Product/process change notification

PCN N° 2021-095-A

Introduction of an additional assembly location at Hana Semiconductor (Ayutthaya) Co., Ltd. for products in PG-DSO-14-44 & PG-DSO-16-21

Assembly Site Code Marking

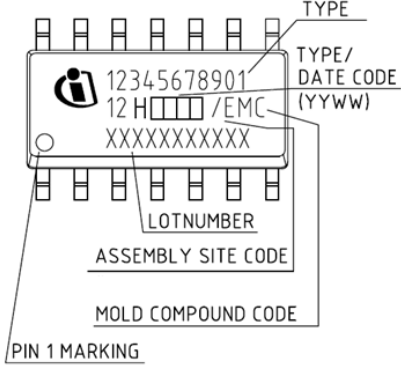
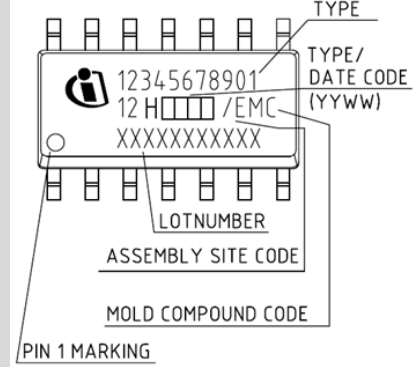
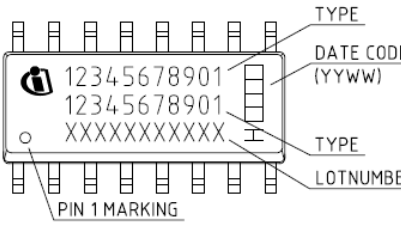
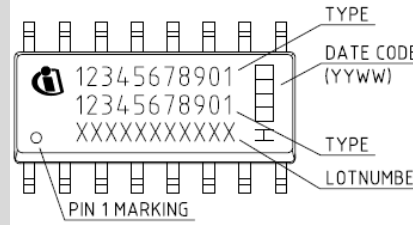
Assembly Location

| <ul style="list-style-type: none"> ATX Assembly & Test (Shanghai) Ltd., Shanghai, China | <ul style="list-style-type: none"> ATX Assembly & Test (Shanghai) Ltd., Shanghai, China or Hana Semiconductor (Ayutthaya) Co., Ltd, Ayutthaya, Thailand |
